# DESIGN COMPLIANCE REVIEW

## ACCESS

### 11-17 Columbia Lane Homebush

**Report Prepared for:** JQZ Group Pty Ltd.  
**Report Prepared by:** Doug Melloh  
**Our Ref:** AN19-213033  
**Date:** 09 August 2019

drawing title Basement 1

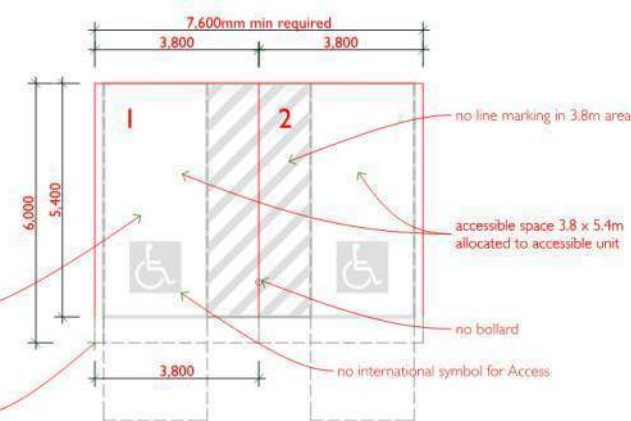
2 Adaptable parking spaces  
AS 4299-1995  
Compliance

adaptable 6.0x 3.8m space  
ACHIEVED with AS4299-1995  
Areas can comply with current AS 2890.6  
no line marking in 3.8m area  
accessible space 3.8 x 5.4m allocated to accessible unit  
no bollard  
no international symbol for Access  
this option preferred as AS 4299 compliance is achieved, as easy strata nomination of parking spaces

BCA D3.4  
Exempt area due to intended function and use.

drawing title Basement 2

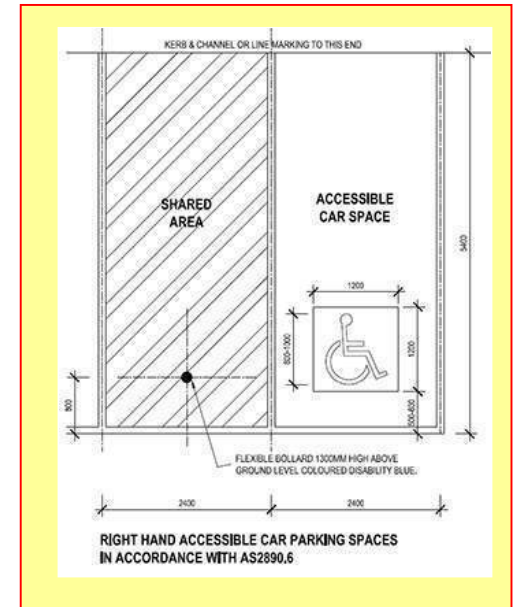
Pavement markings shall be provided as follows:

(a) Dedicated parking spaces shall be outlined with **unbroken lines 80-100mm wide on all sides** excepting any side delineation by a kerb, barrier or wall;

(b) Shared areas shall be marked as follows:

(i) Walkways within or partly within a shared area shall be marked with unbroken longitudinal lines on both sides of the walkway excepting any side delineated by kerb, barrier or wall.

drawing title Ground Floor

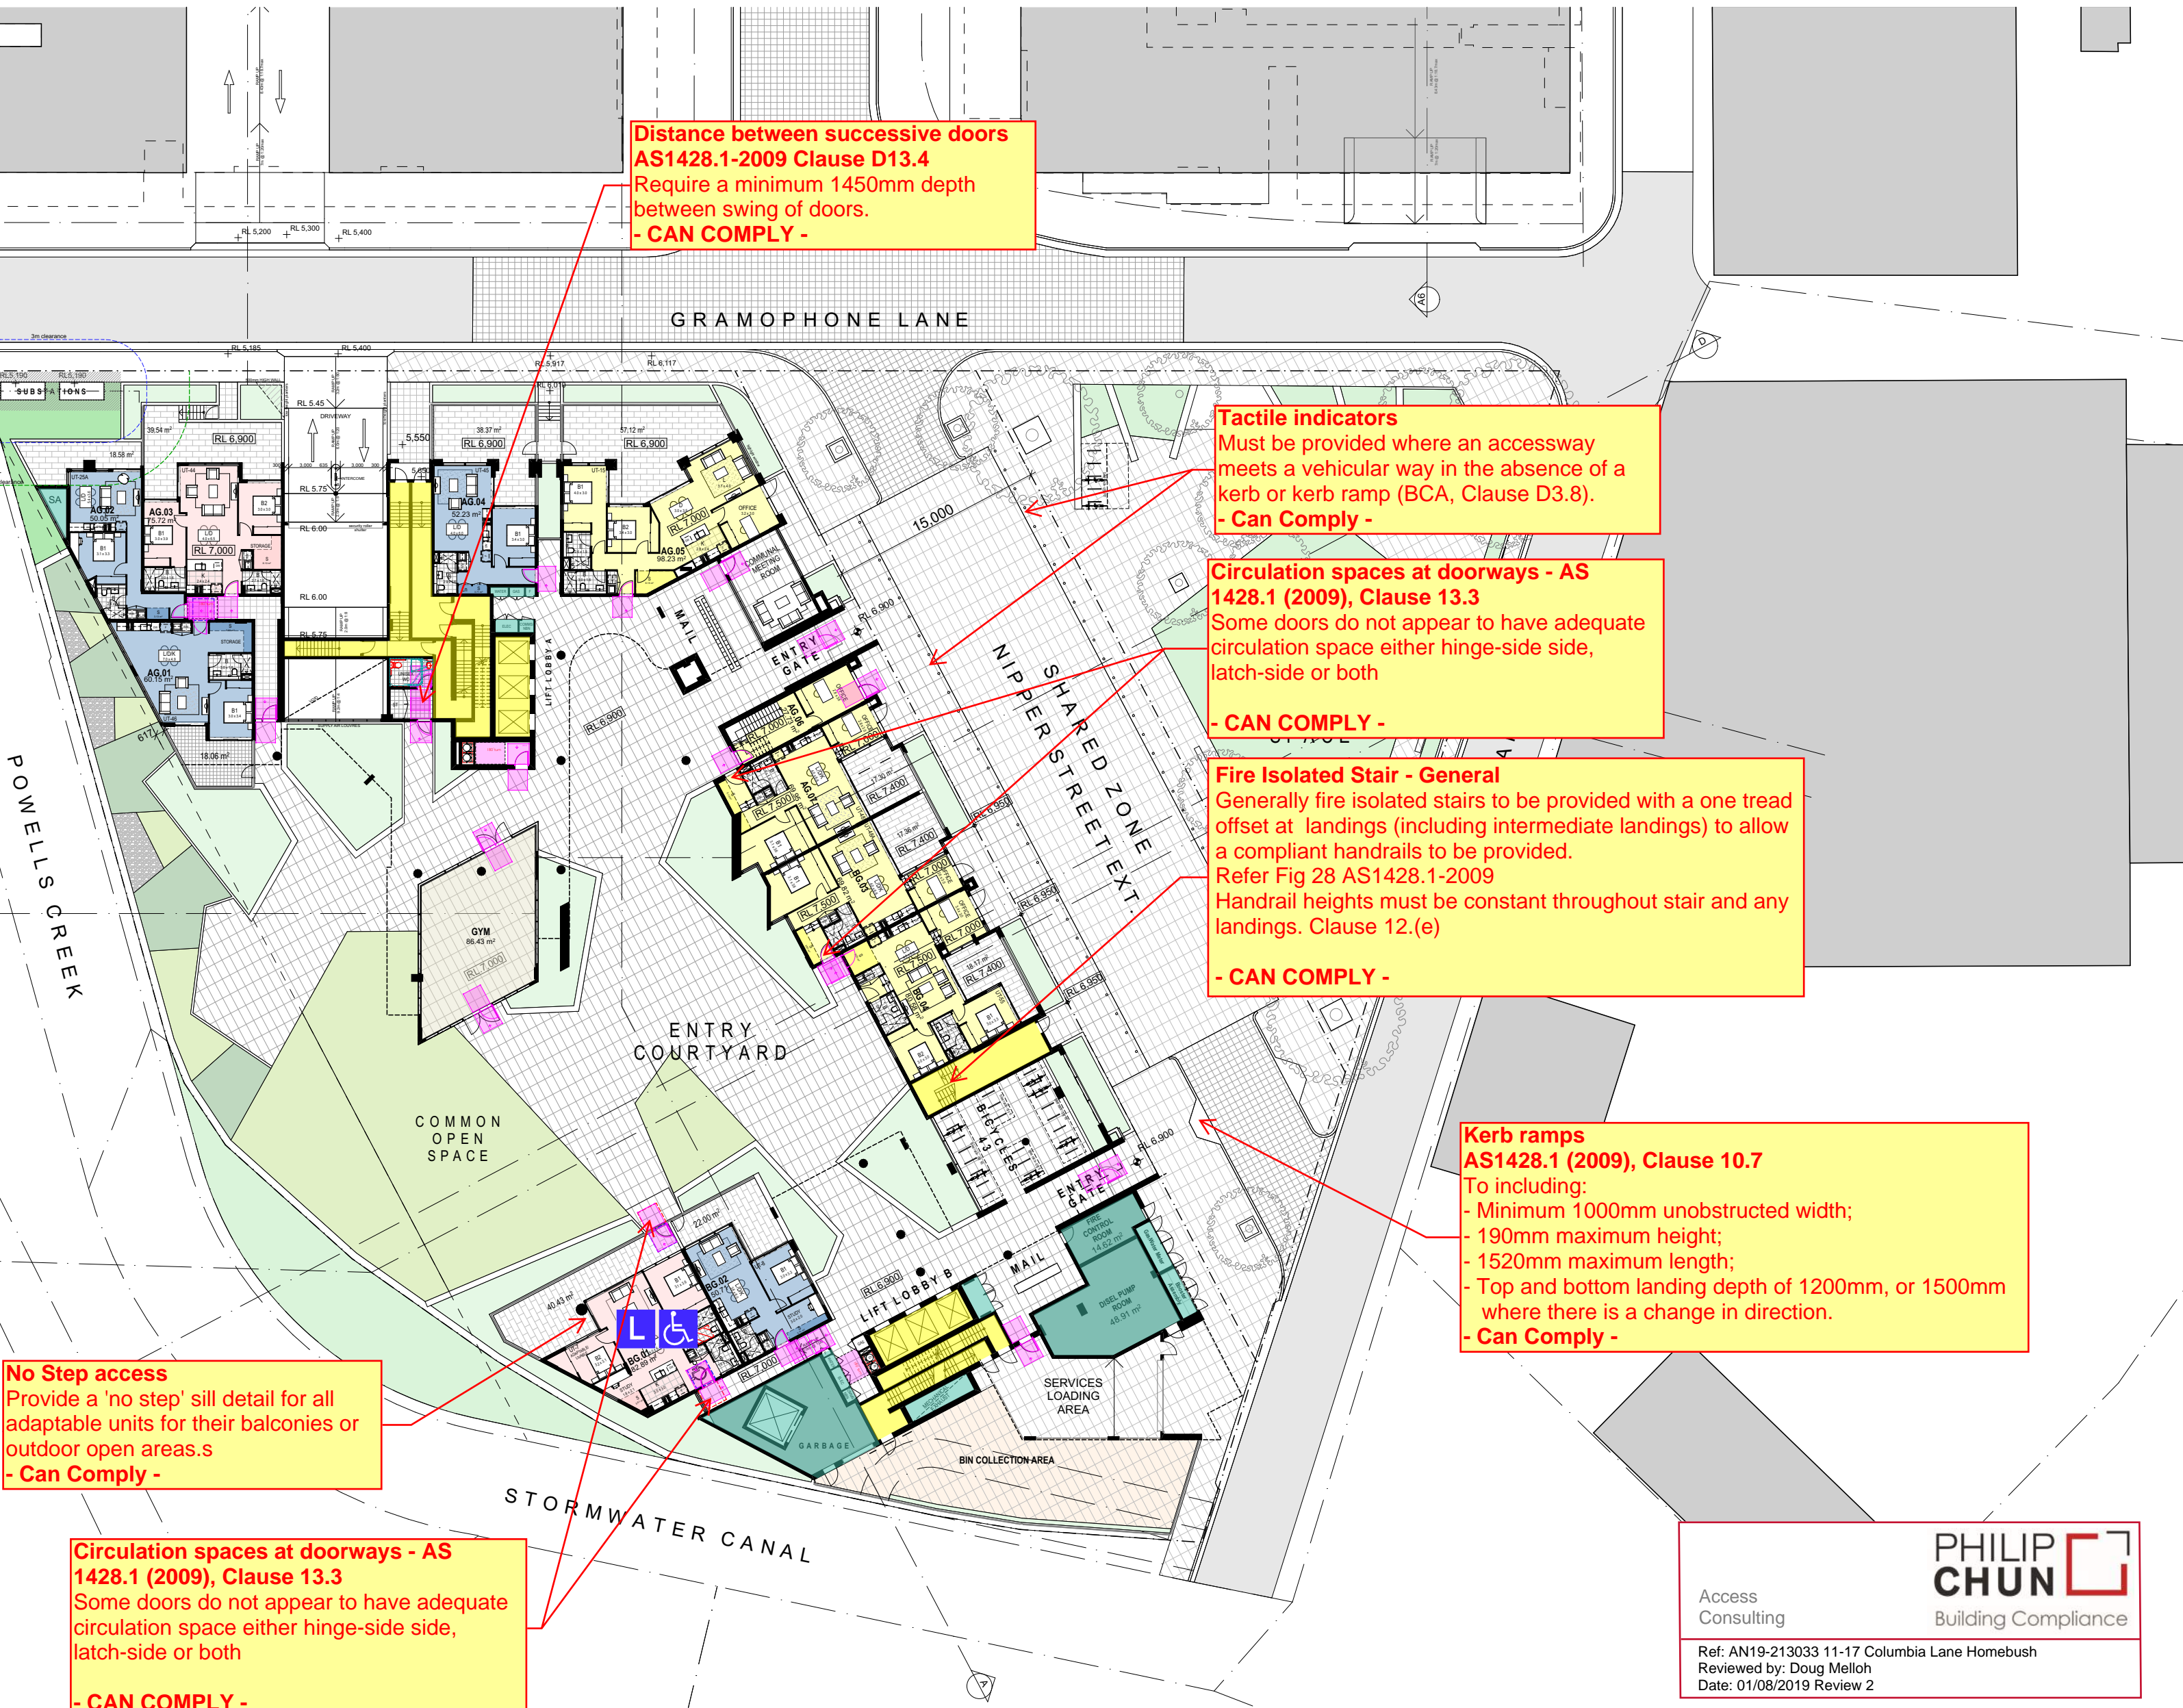
**Tactile Indicators**  
**BCA, Part D3.8 and AS 1428.4.1 (2009)**  
For a building required to be accessible, tactile ground surface indicators must be provided to warn people who are blind or have a vision impairment that they are approaching a hazard complying with NCC D3.8 and AS 1428.4.1 (2009).

**When available appropriate drawings detailing tactile indicators should be provided for review.**

**Edge of carriageway** - Where a pedestrian area joins a carriageway at grade (i.e. on the same level) or to delineate the pedestrian area from the carriageway, TGSIs shall be provided in accordance with Figures 2.5(A) and 2.5(B) AS 1428.4.1 being a minimum TGSI width of 600mm, installed 300+/-10mm from the edge of the carriageway at grade.

**Stairways** - TGSIs are to be provided setback 300mm from the top and bottom of the stairway, for a depth of 600-800mm, for the full width of the path of travel.

**Kerb ramps**  
**AS1428.1 (2009), Clause 10.7**  
To including:  
- Minimum 1000mm unobstructed width;  
- 190mm maximum height;  
- 1520mm maximum length;  
- Top and bottom landing depth of 1200mm, or 1500mm where there is a change in direction.  
- Can Comply -

**No Step access**  
Provide a 'no step' sill detail for all adaptable units for their balconies or outdoor open areas.s  
- Can Comply -

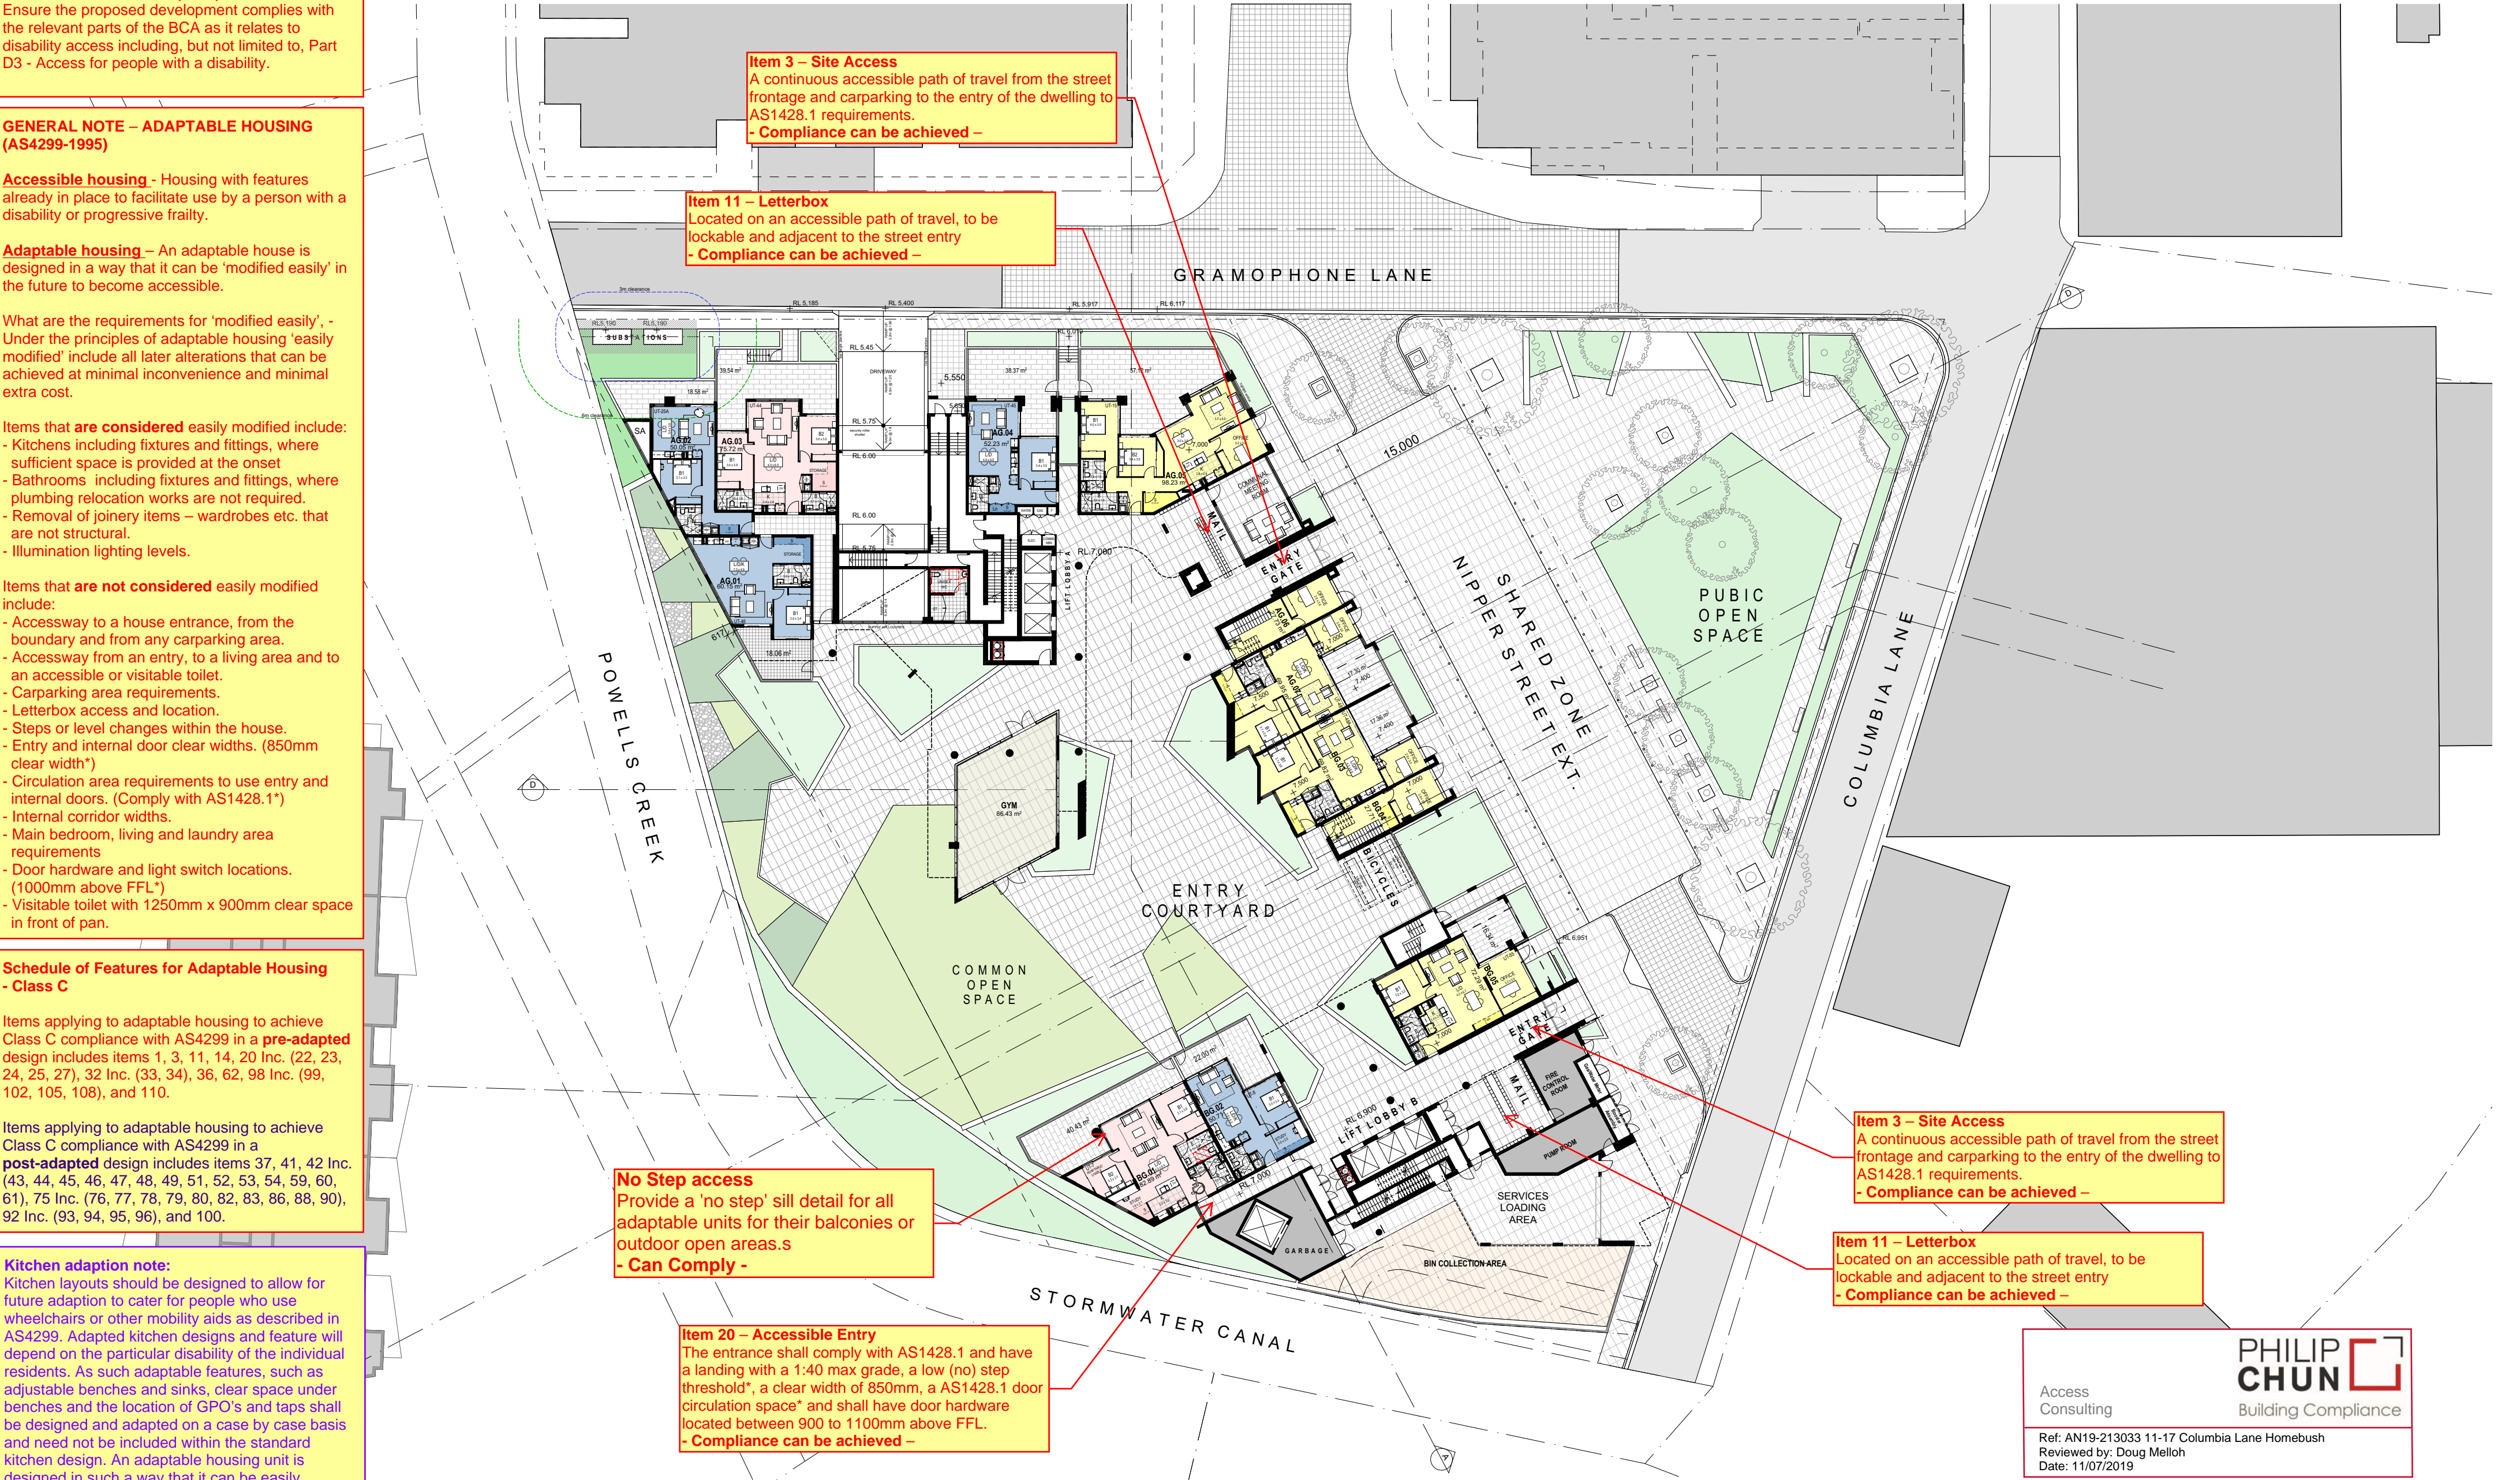
**No Step access**  
Provide a 'no step' sill detail for all adaptable units for their balconies or outdoor open areas.s  
**- Can Comply -**

**Item 20 – Accessible Entry**  
The entrance shall comply with AS1428.1 and have a landing with a 1:40 max grade, a low (no) step threshold\*, a clear width of 850mm, a AS1428.1 door circulation space\* and shall have door hardware located between 900 to 1100mm above FFL.  
**- Compliance can be achieved –**

**Item 3 – Site Access**  
A continuous accessible path of travel from the street frontage and carparking to the entry of the dwelling to AS1428.1 requirements.  
**- Compliance can be achieved –**

**Item 11 – Letterbox**  
Located on an accessible path of travel, to be lockable and adjacent to the street entry  
**- Compliance can be achieved –**
